**MEMORANDUM**

**To:** Zoning Board of the City of Stamford  
**From:** Lisa L. Feinberg  
**Date:** December 5, 2025  
**Re:** Response to Comments on ZB App. No. 225-29 (120-C Long Ridge Road)

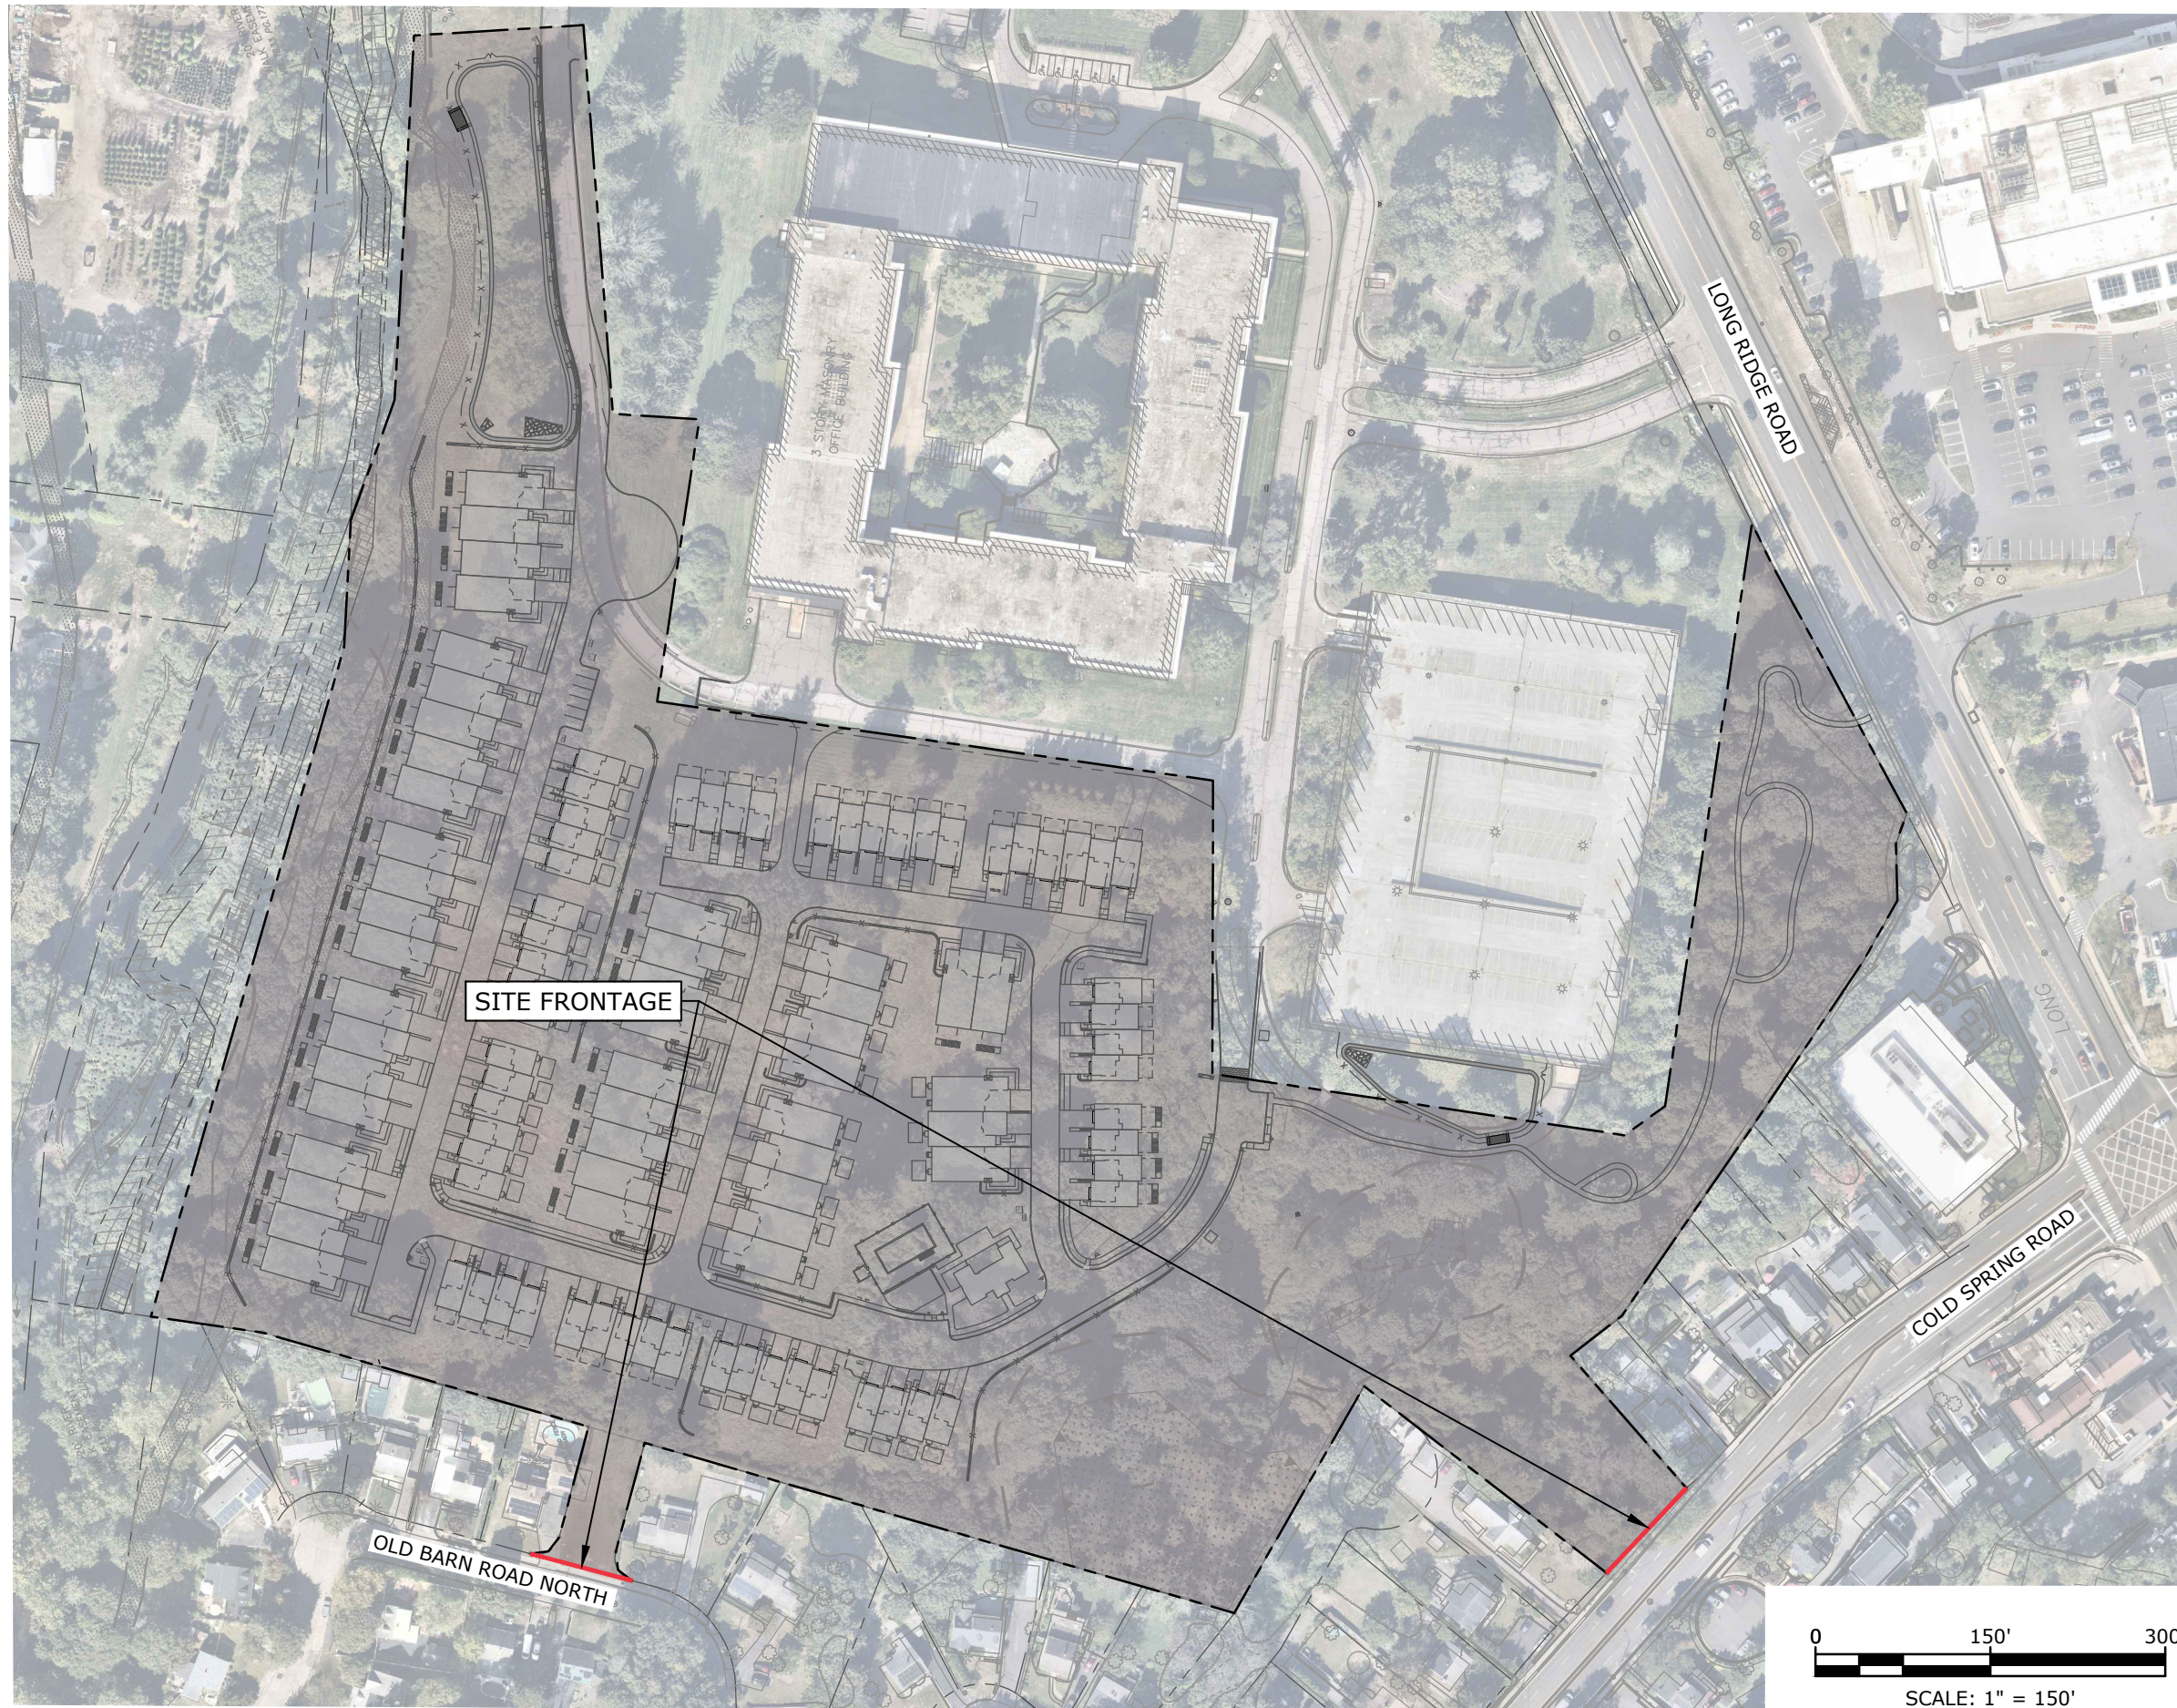
5. *Please confirm what elements of the architectural design are subject to change.*

As noted during the public hearing, only the rear façades of the buildings are subject to change based on buyer preferences related to deck-options. The remainder of the buildings will be consistent with the renderings and elevations submitted. The architectural drawings have been updated to remove any reference to preliminary or conceptual images and have been included herewith.

# American Playground Company Example

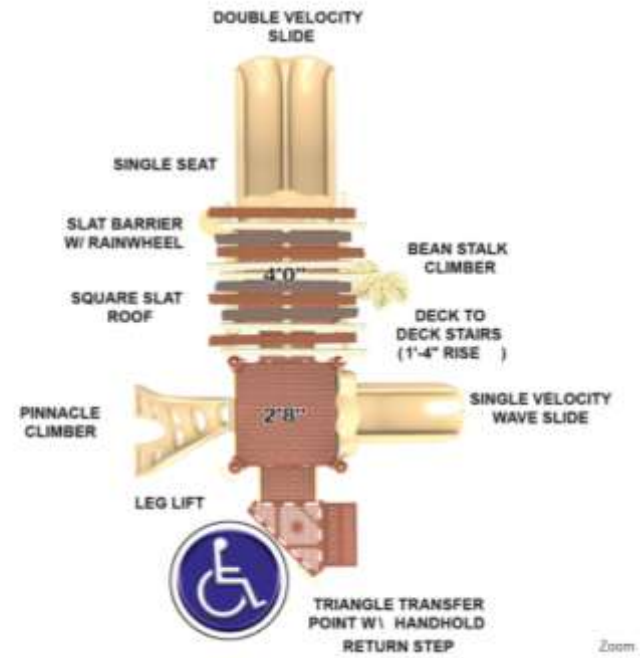
3. *Consider providing a larger child play area.*

However, at the request of the Zoning Board, the Applicant explored opportunities to enhance the size of the play area. The Stamford Zoning Regulations require the lesser of 1,000 square feet or 25% of the area of the usable open space. The proposed play area will be 1,031± square feet. While the expansion is minimal, it will accommodate an attractive playscape. Enclosed herewith is an example of a playscape designed by American Playground Company that could be contained in this space. For all of these reasons, the Applicant submits that the proposed child play area complies with the regulations and is appropriate for the project.

Cold Spring Road Frontage

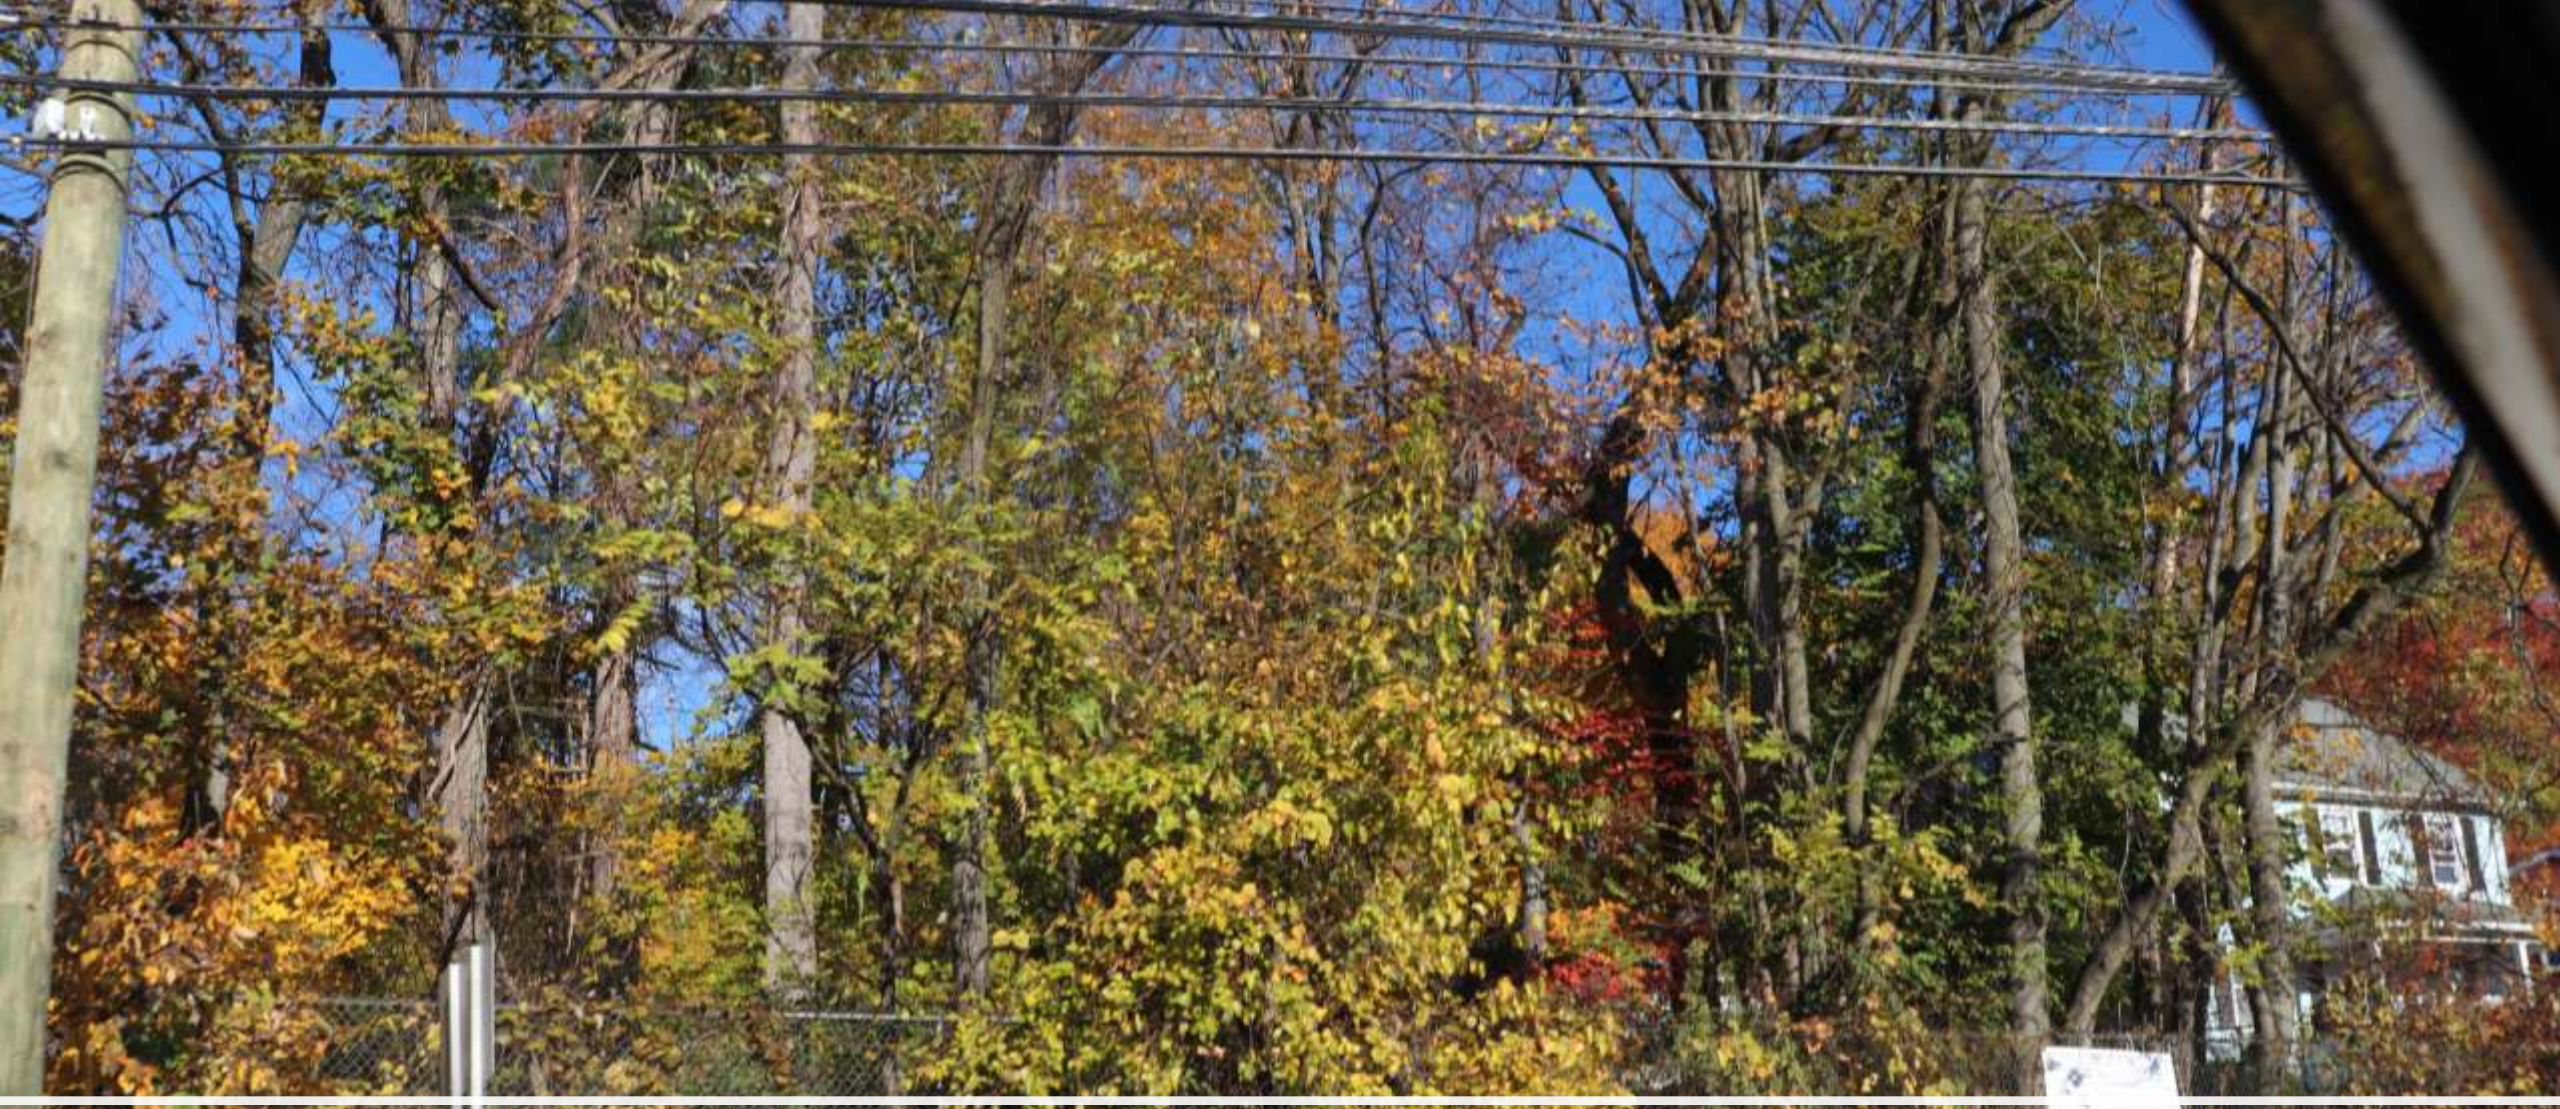
4. *Update the landscape plan to depict the existing trees counted toward the street tree requirement.*

Enclosed please find revised landscape plans prepared by Environmental Land Solutions, LLC, (ELS) revised to December 5, 2025. ELS field located eight (8) existing trees along the Long Ridge Road frontage and Sheet LP.4 has been revised to depict the number and location of each existing street tree. The Applicant has also identified a minimum of six (6) street trees along the Cold Spring Road frontage which are depicted on Sheet LP.3. Photographs of these trees are also included herewith.
